Access Compliance Report Public Rights-of-Way (Curb Ramps)

Intersection ID: 9641	Main Street: CONDON_ST	Cross Street: PATTON_AV	Location: SW
ADA ID: 62B20B01B701	Ramp Type: Directional1	Initial Pass/Fail: Fail	Overall Compliance: No Severity Score: 12.5

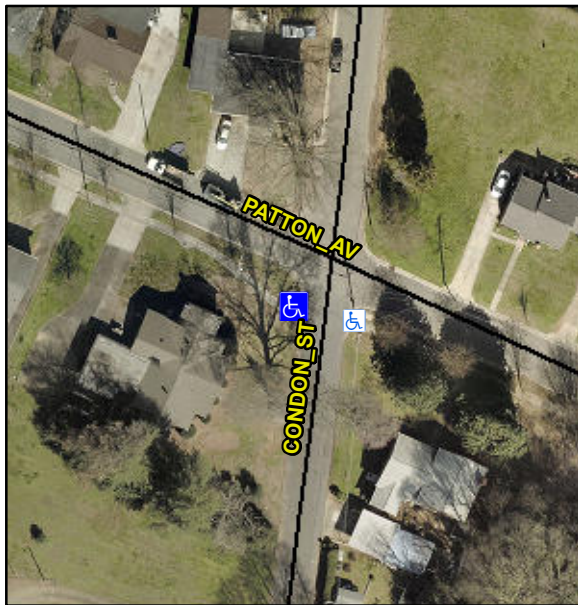
R304.2.2

Remove & Replace Entire Ramp.
